## **ATTACHMENT 5**

Peer Review Letters

**South32 – Illawarra Coal**  
**Dendrobium Mine: Plan for the Future**  
**Application**

**KA Peer Review of HydroSimulations**  
**Groundwater Modelling Assessment**

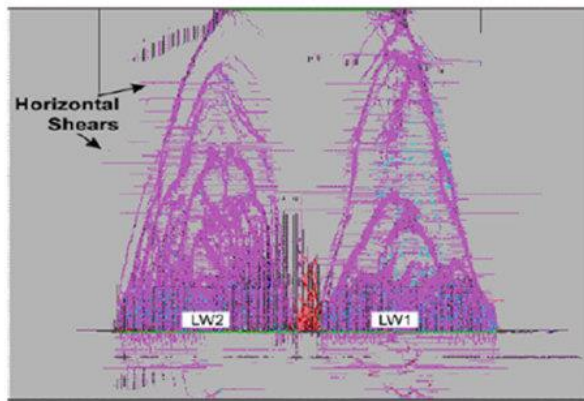
'Stacked' drains application includes setting up these above the mined out seam to a given height and are applied progressively but with changes in conductance to allow for porous media flow rather than fracture flow and other factors which are then allowed to drain as indicated by the model. HS (2019) reports that method 2 has been used largely because it provided better results for matching the 'peakiness' of Area 2 inflows and also was faster and with much improved stability. The stacked drains conductance was changed in order to match recorded inflow and to allow some control and reduction of fracture hydraulic conductivity in the vertical direction. Details are given in Section 6.9.1 in the HS report. KA has no objection to the use of this 'Stacked Drain' method as it has been used by MER for a number of years and has proved to be suitable. In addition it has been found on some projects by MER to overestimate the mining effects such as drawdown and overall inflow and therefore can be considered to be a conservative overall methodology for determining fracture propagation and associated draining in the geological profile.

From Figure 4-20 HS 2019. FLAC2D fracture simulation above caved zone.

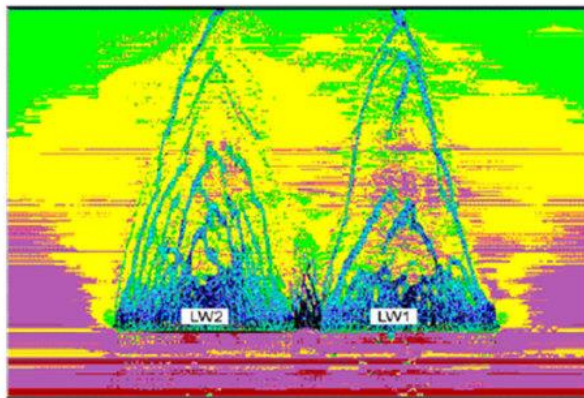
It is to be noted that the vertical fractures and vertical hydraulic conductivity shown, in the FLAC2D simulations, copied Figure 4.20 above, does not propagate upward at high elevations in a midway position and in a direct vertical direction above the panels shown, but in preferred directions along the edges of the parabolic fracture zones. It should also be noted that there is no horizontal fracture zone observed in these figures that are due to tensile forces that are typically 10 to 30m below the ground surface. It is understood that the FLAC2D code does not simulate these horizontal fractures (Gale KA pers. comm.). It is quite possible that in reality that the presence of the horizontal shallow fracturing zone would still allow in part flow downstream and likely re-emergence outside of the mining zone with a proportion of inflow migrating down to the mining zone through vertical fracture zone as depicted in HS Figure 4.20. It suggests further that the 'stacked drains' approach by HS would very likely capture most flow and therefore would indeed be conservative with respect to mine inflow.
